RS-20-130

Byron Station, Units 1 and 2  
Renewed Facility Operating License Nos. NPF-37 and NPF-66  
NRC Docket Nos. STN 50-454, STN 50-455 and 72-068

Subject: License Amendment Request – Proposed Changes to Byron Emergency Plan for Post-Shutdown and Permanently Defueled Condition

Figure A-2: Agency Response Organization Interrelationships

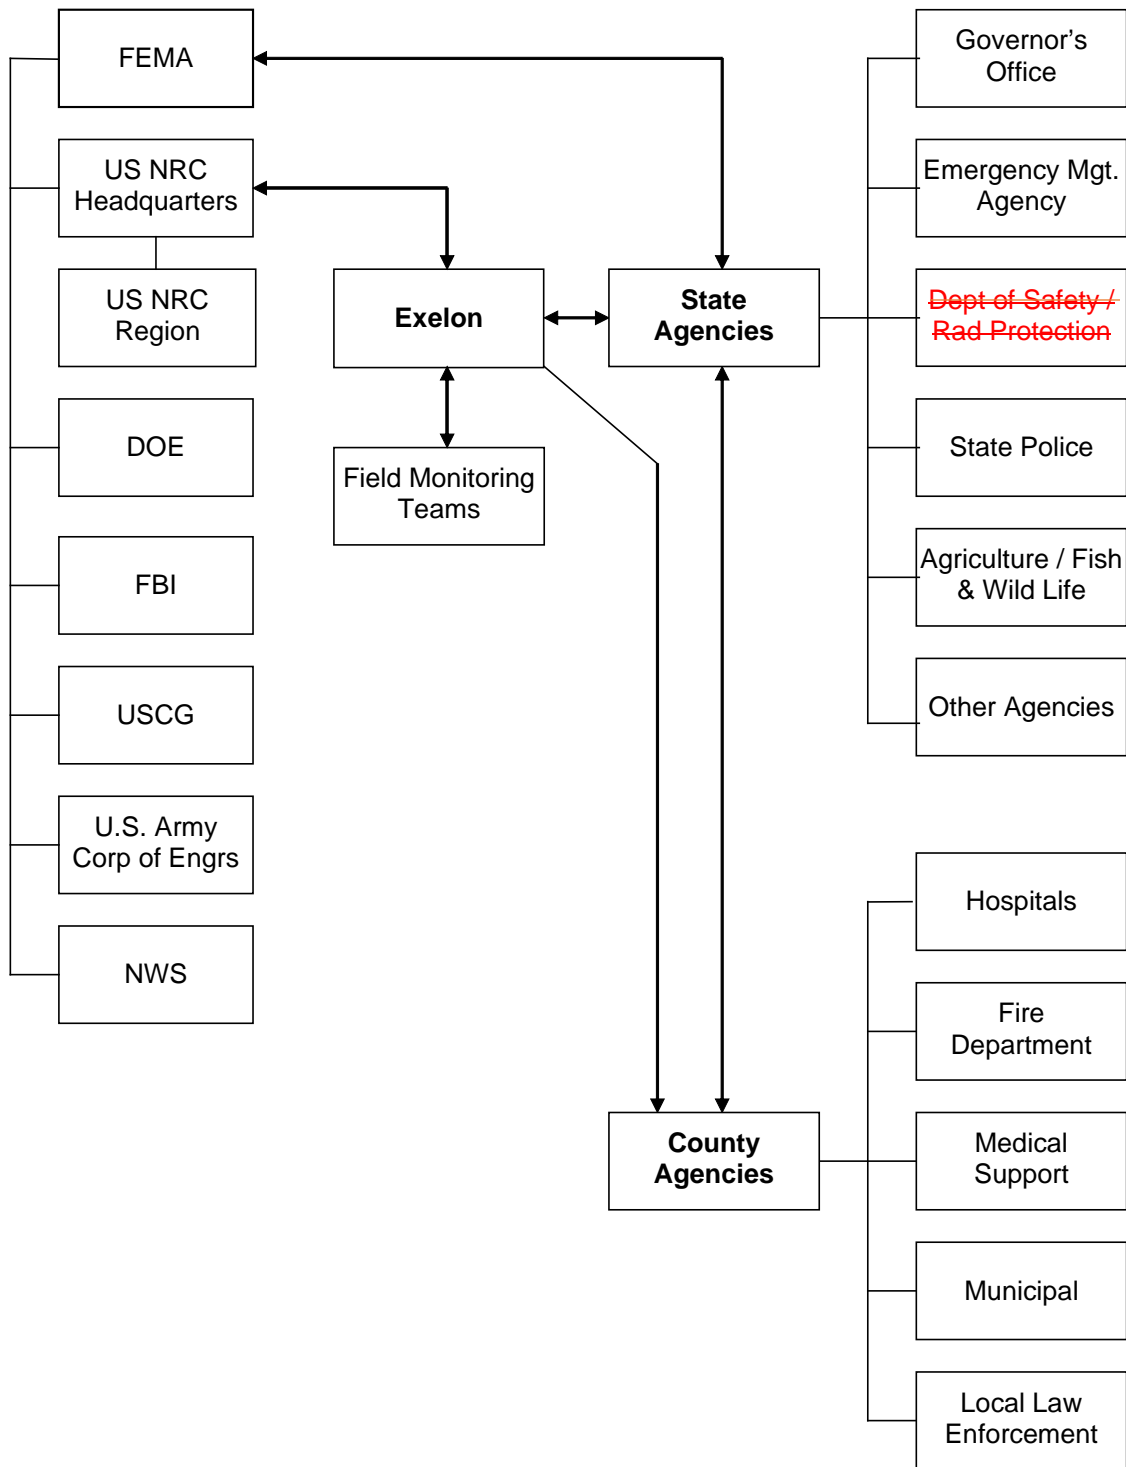
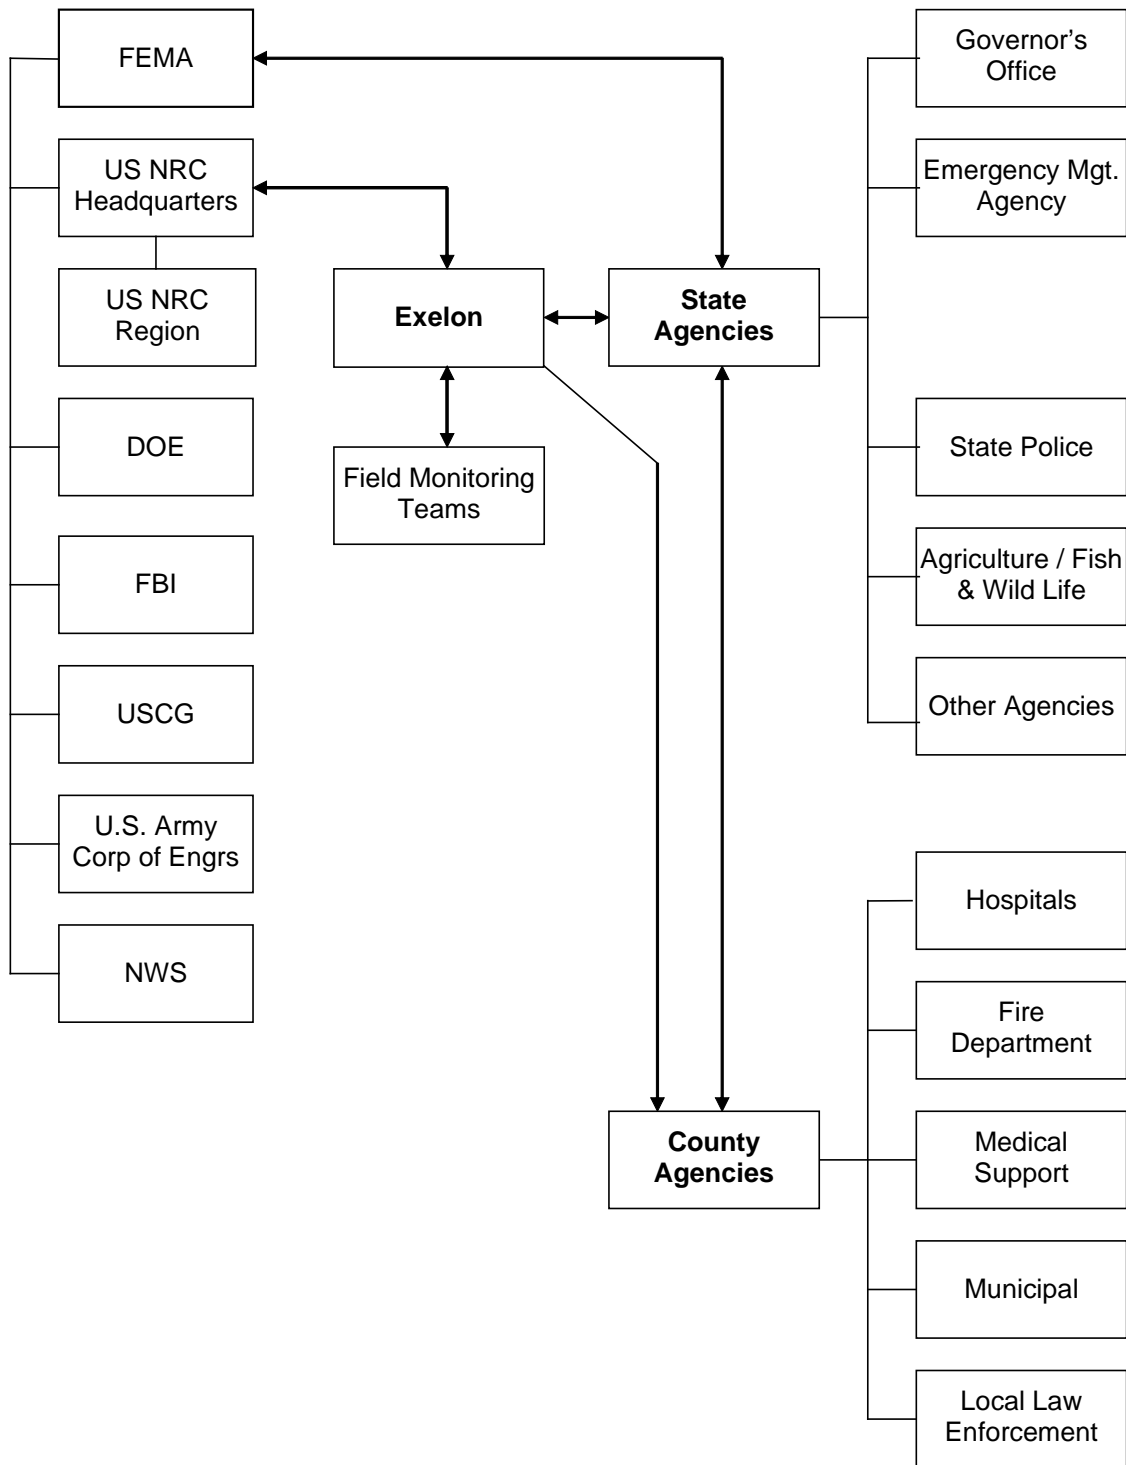
EP-BY-1000 Part II Section A, Fig. A-2 <u>Byron Nuclear            Emergency Response            Organization</u>	<p><b><u>Figure A-2: Agency Response Organization Interrelationships</u></b></p> <p>Dept of Safety / Rad Protection</p>	<p><b><u>Figure A-2: Agency Response Organization Interrelationships</u></b></p> <p><del>Dept of Safety / Rad Protection</del></p>	The revision deletes the reference to the Dept of Safety / Rad Protection group. The change was made at the request of IEMA based on changes to their Organization Structure. The Dept of Safety / Rad Protection group no longer exists.

Figure B-1a: ~~Exelon~~-Byron Overall ERO Command Structure

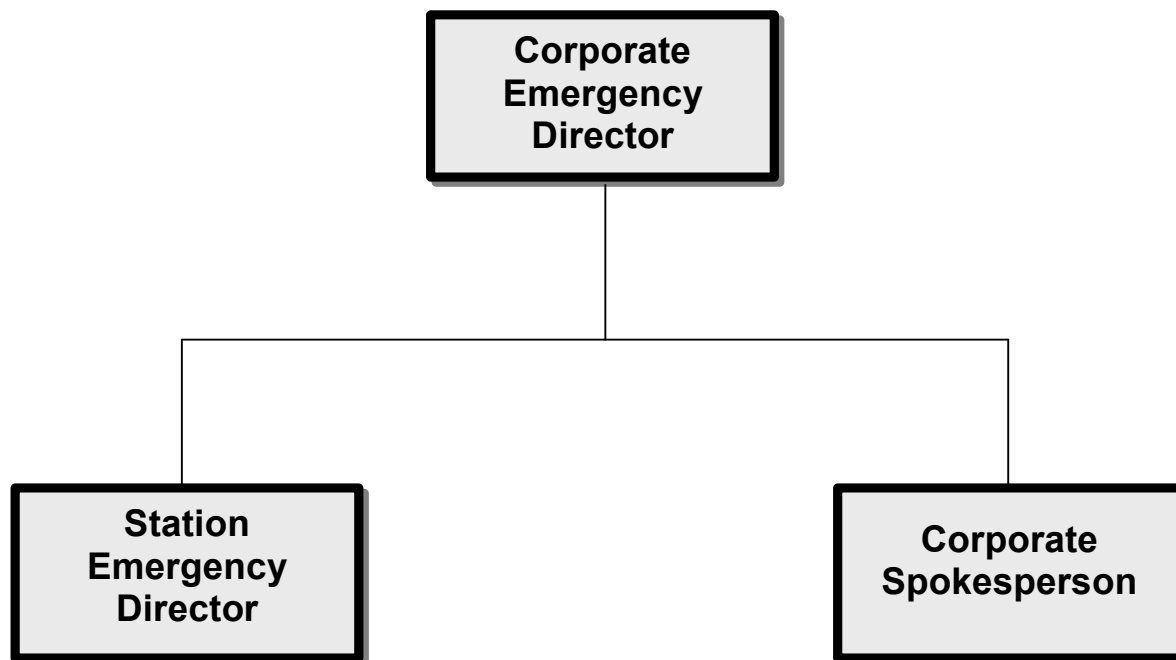
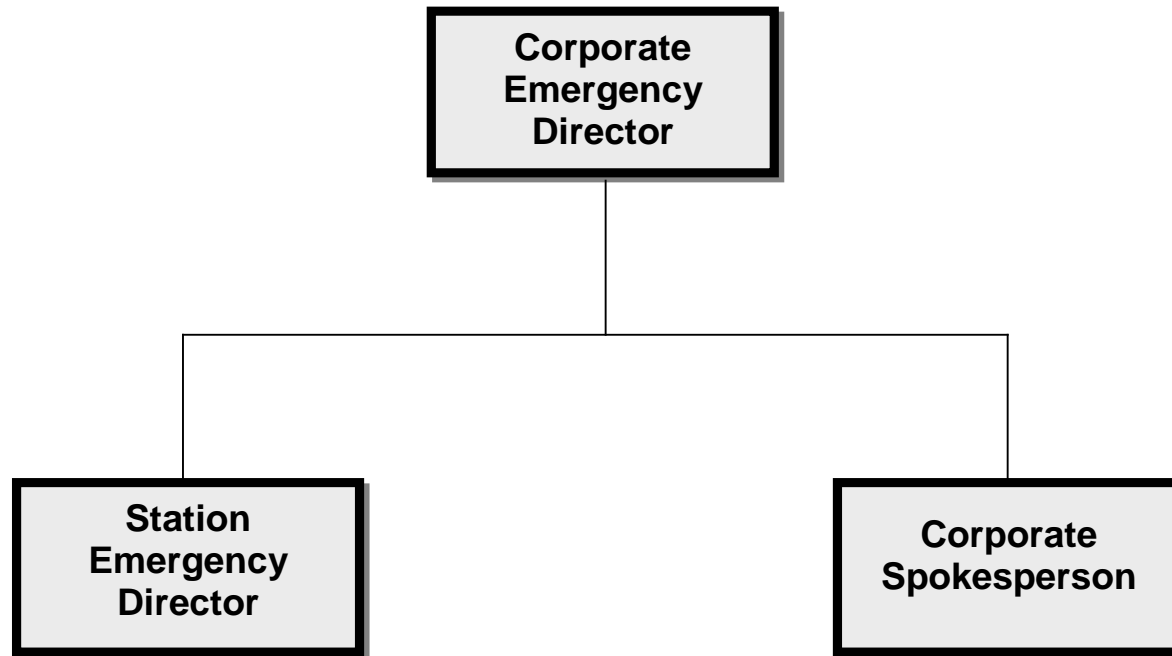
<p>EP-BY-1000 Part II Figure B-1a</p>	<p>Figure B-1a: Exelon Overall ERO Command Structure</p>	<p>Figure B-1a: <del>Exelon</del> <b>Byron</b> Overall ERO Command Structure</p>	<p>The revision replaces Exelon with Byron as it pertains to the Overall ERO Command Structure. EP functions for the Byron ERO command structure will continue to be maintained.</p>
<p>EP-BY-1000 Part II Figure B-1b</p>	<p>Figure B-1b: Emergency Onsite Organization</p> 	<p>Figure B-1b: Emergency Onsite Organization</p> 	<p>The TSC Core/Thermal, Mechanical, and Electrical Engineer positions are being deleted from the Byron ERO and are being replaced by the TSC Engineer. This revision is further discussed in Attachment 1, Section 5.3.7 Evaluation of Proposed Changes.</p> <p>The revision also deletes the OSC I&amp;C, Electrical and</p>

Figure B-1b: Emergency Onsite Organization

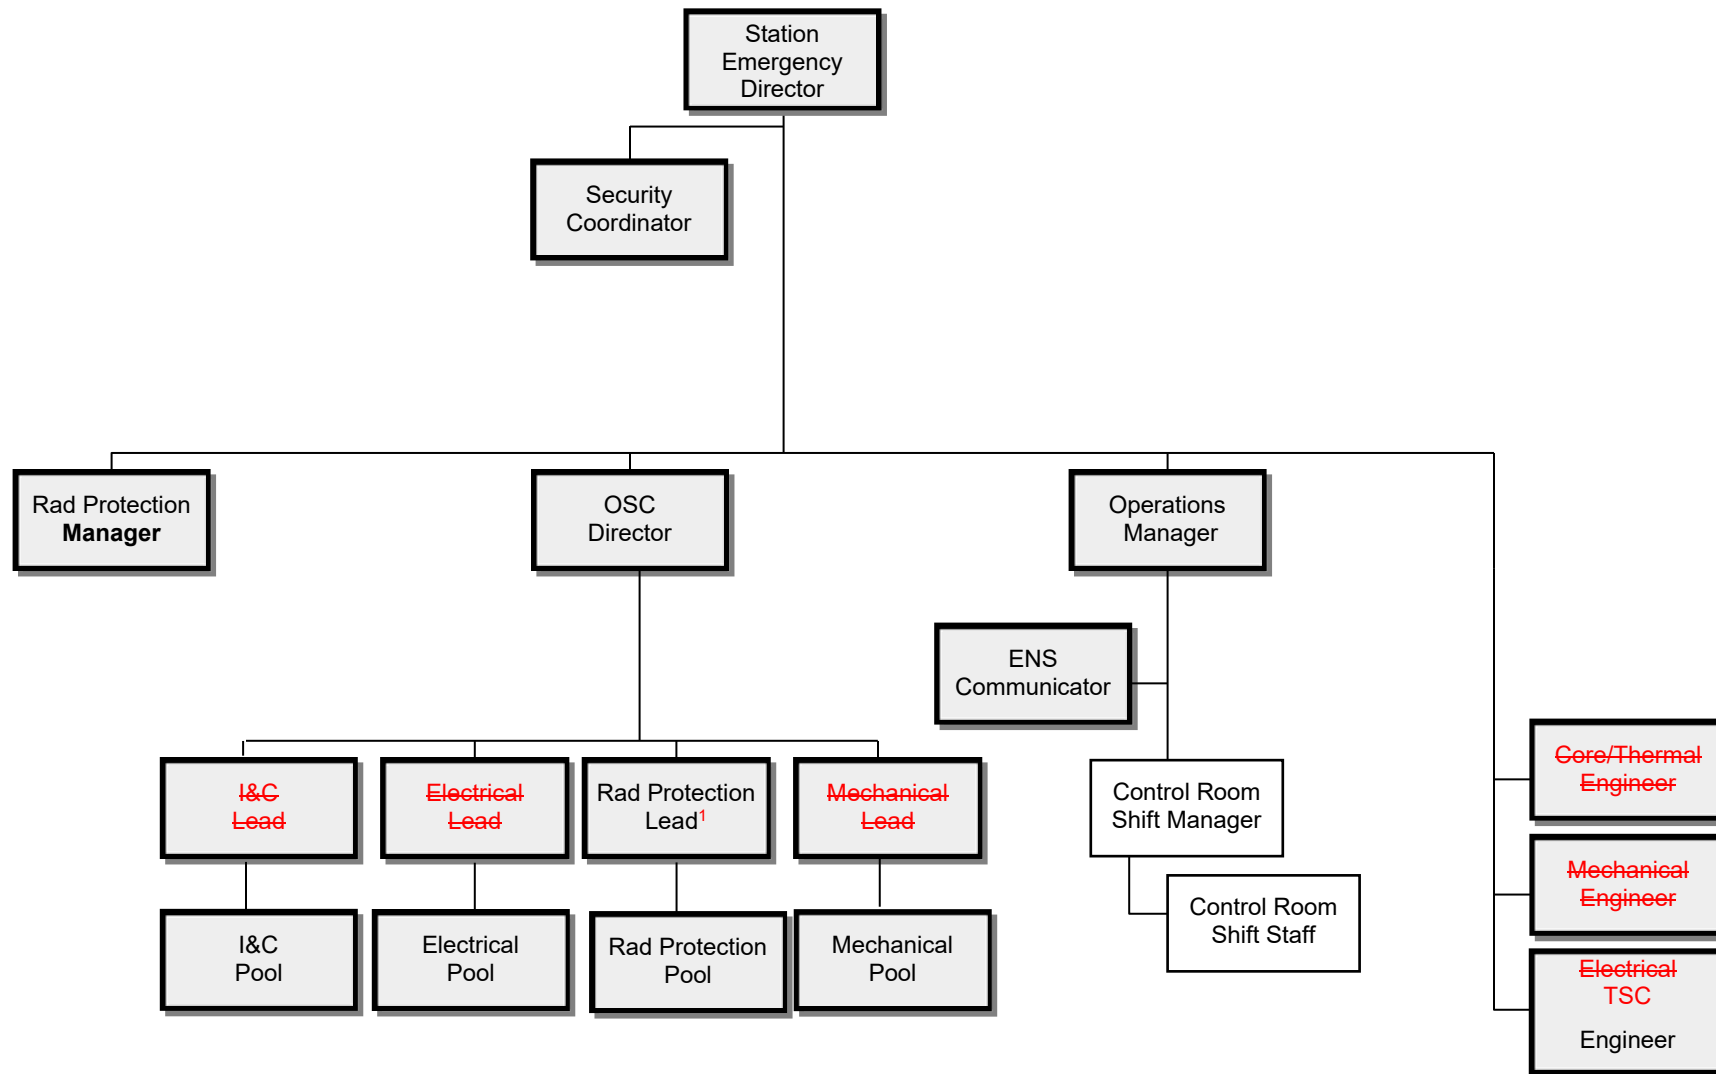
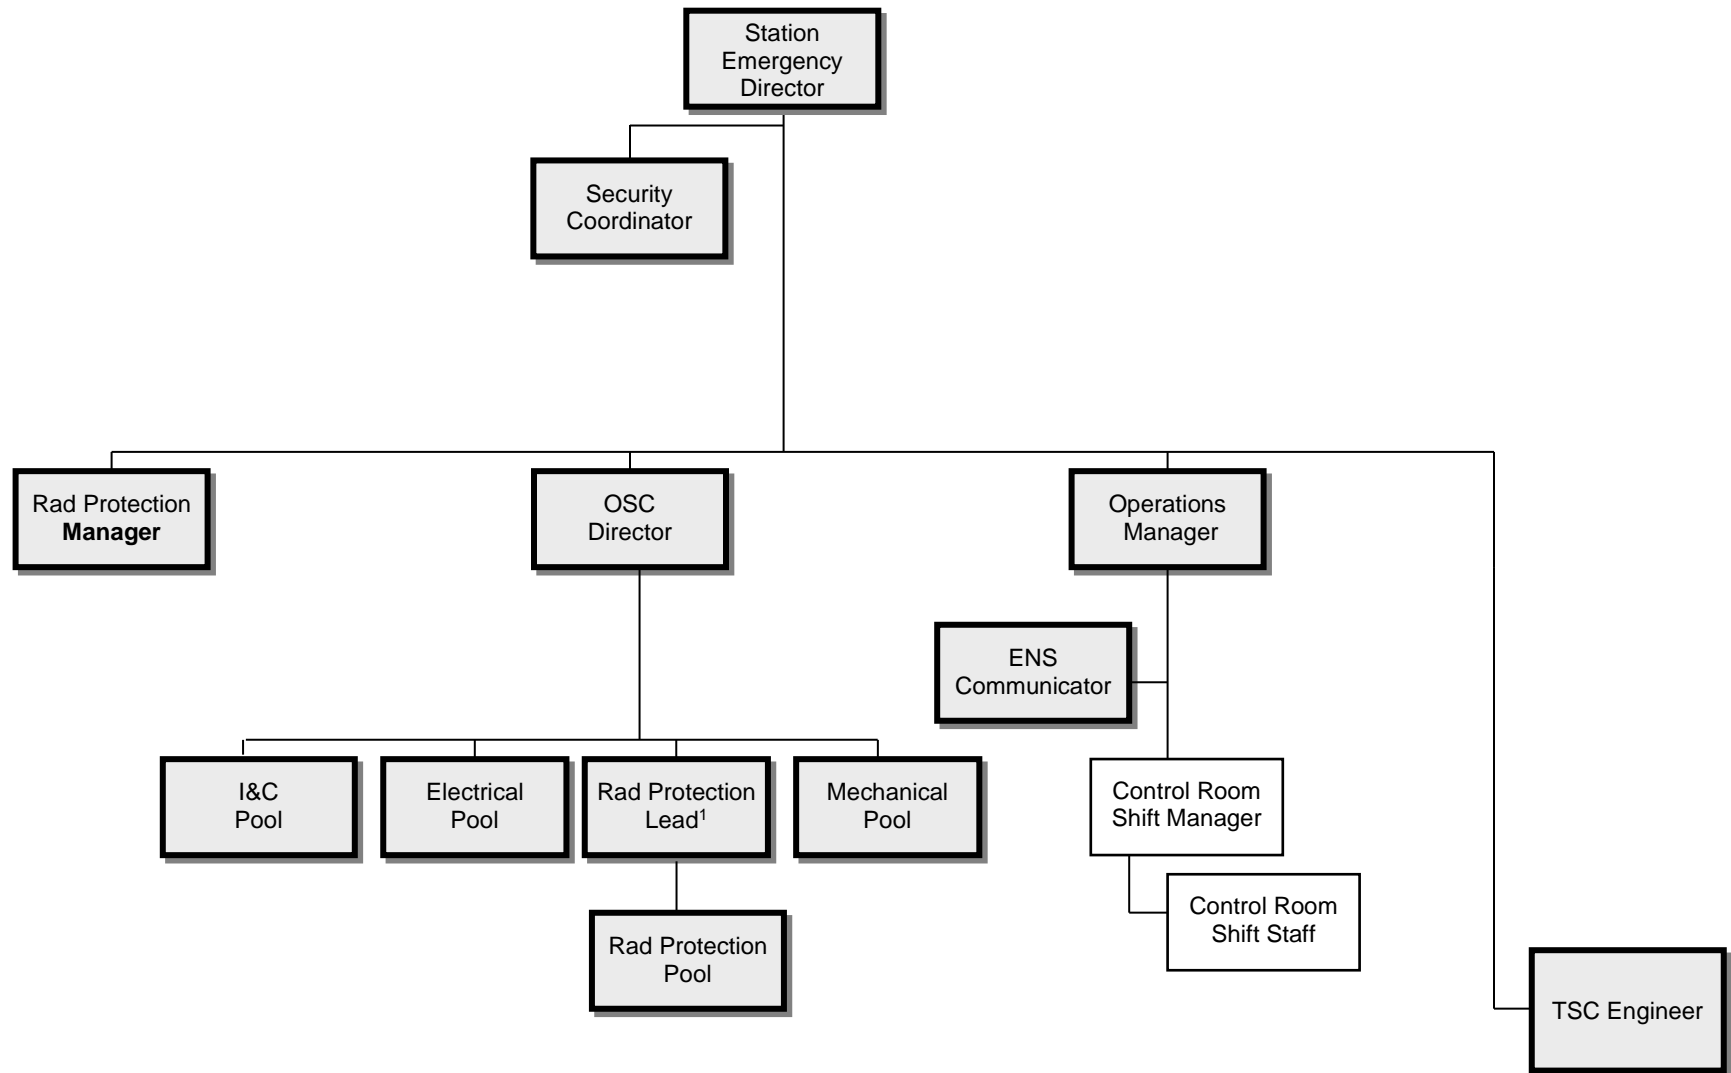
<sup>1</sup> Rad Protection Lead responsibilities will be performed by a Rad Protection Pool responder as a collateral function.

Figure F-1: Exelon Notification Scheme (For Full Augmentation)

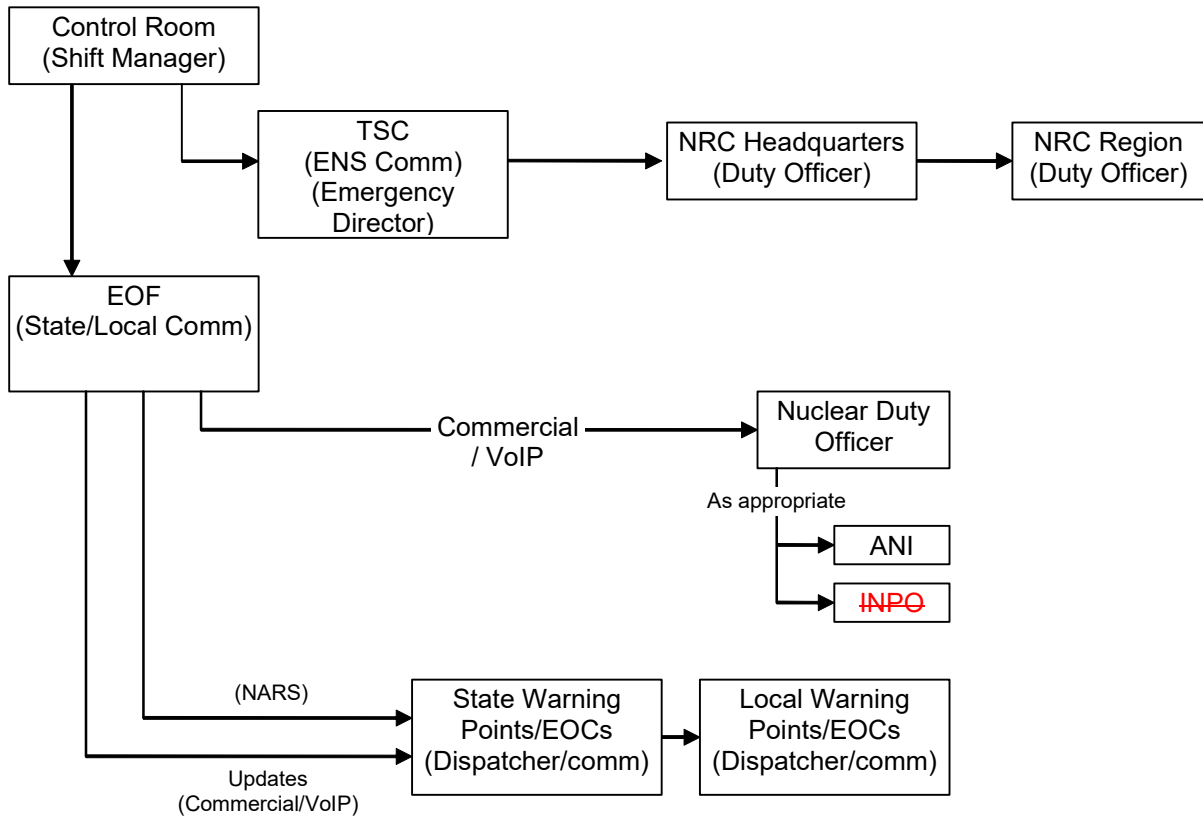
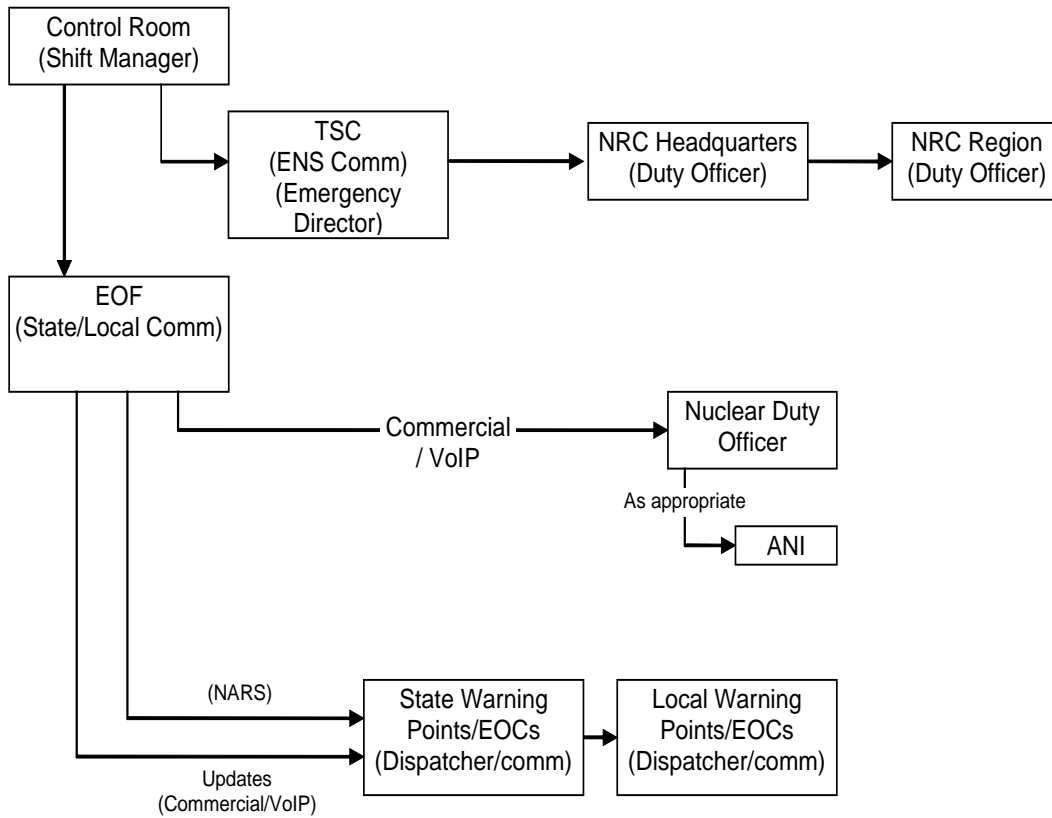
Part II, Figure F-1 Exelon Notification Scheme (For Full Augmentation)			The revision reflects deletion of INPO because INPO's oversight would not apply to a permanently shutdown facility
Part II.H.1.a Control Room, Technical Support Center, and Operations Support Center - Station Control Room	<p>a. <u>Station Control Room:</u> The Control Room is the centralized onsite location from which the Nuclear Station's reactors and major plant systems are operated. The Control Room is equipped with instrumentation to supply detailed information on the reactors and major plant systems. The Control Room is continuously staffed with qualified licensed operators. The Control Room is the first onsite facility to become involved with the response to emergency events. Control Room personnel must evaluate and effect control over the emergency and initiate activities necessary for coping with the emergency until such time that support centers can be activated. These activities shall include:</p> <ul style="list-style-type: none"> <li>• Reactor and plant control.</li> </ul> <p>&lt;...&gt;</p>	<p>a. <u>Station Control Room:</u> The Control Room is the centralized onsite location from which the Nuclear Station's <del>reactors and major plant systems</del> <b>necessary to support the spent fuel pool</b> are <del>monitored</del> <b>operated</b>. The Control Room is equipped with instrumentation to supply detailed information on the <del>reactors and major plant systems</del>. The Control Room is continuously staffed with qualified <del>licensed</del> operators. The Control Room is the first onsite facility to become involved with the response to emergency events. Control Room personnel must evaluate and effect control over the emergency and initiate activities necessary for coping with the emergency until such time that support centers can be activated. These activities shall include:</p> <ul style="list-style-type: none"> <li>• <del>Reactor and Plant</del> control.</li> </ul> <p>&lt;...&gt;</p>	This revision removes the reference to the site reactors and major plant equipment.  The permanent shutdown of the Byron reactor makes these condition reference unnecessary within the Emergency Plan.
